SIL 3308-05 – Revision B SN3308 EHSI Service Information Letter

Date: 04/27/2007
Regarding: Interfacing with Garmin GNS 400W/500W series receivers
Revision history: B, Added Maintenance Page configuration settings
A, Initial release

To enable display of vertical deviation during a GPS approach with vertical guidance from a Garmin GNS 400W/500W series receiver.

Maintenance Page 15: NAV CHANGE

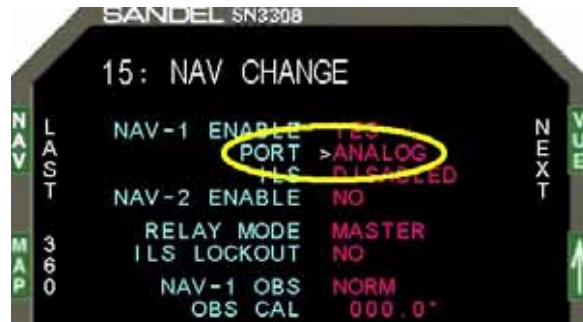
1. Under NAV-1 ENABLE, record the current PORT setting for reference (429 PORT-2 or PORT-3). Change the PORT setting from 429 PORT-X to ANALOG.

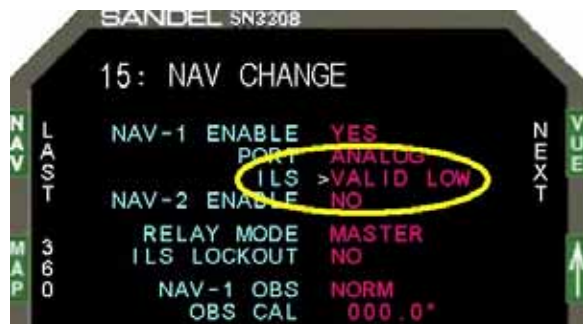
2. Change ILS from DISABLED to VALID LOW

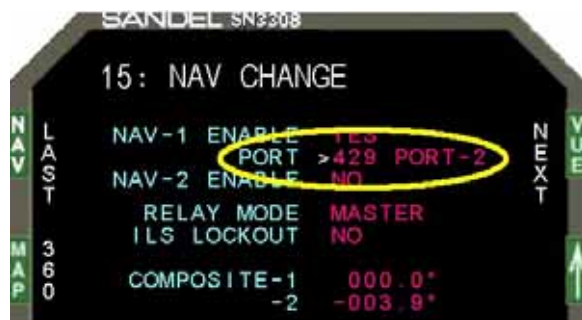
3. Change PORT from ANALOG back to 429 PORT-2 or PORT-3 as recorded in Step 1.
